# Modification Recommended Service Note

## P9374B Keysight Streamline Vector Network Analyzer

Serial Numbers: From MY61100288 to MY61100353

Potential lifted front panel overlay

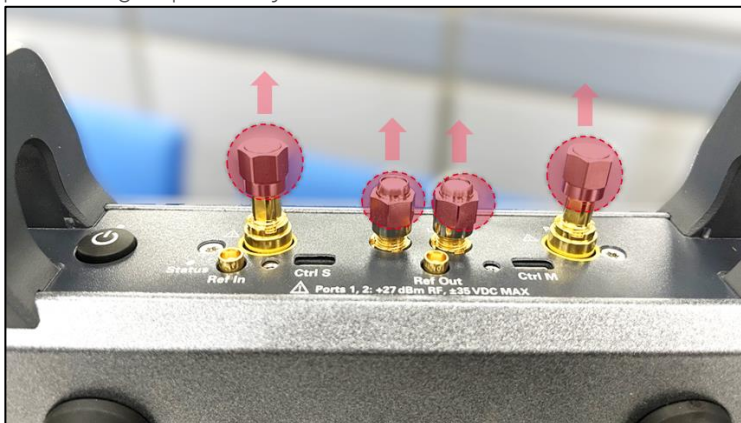
Keysight streamline series vector network analyzer (VNA) of serial number range identified in service note cover page might potentially exhibit the following lifted front panel overlay symptom.

Apart from cosmetic imperfections, the lifted front overlay could have led to non-fully attached *Ctrl S* micro-HDMI cable connector in multi-VNAs setup configuration.

-> Apply this service note only if end users' VNA is exhibiting the following symptom.

Procedure to replace the front panel overlay.

1. Remove the front handles. Detach the 50-ohm termination (LO-In, LO-Out, Port 1 & Port 2) or protecting caps if they are attached to the VNA.

2. Pry open the existing front panel overlay and remove it from front panel.
3. Clean the metal surface thoroughly and ensure it is free of adhesive residue.
4. Affix the new self-adhesive front panel overlay onto the metal surface.
5. Reinstall (reuse) the 50-ohm terminations and port protecting caps accordingly.

6. Reinstall (reuse) the front handles.
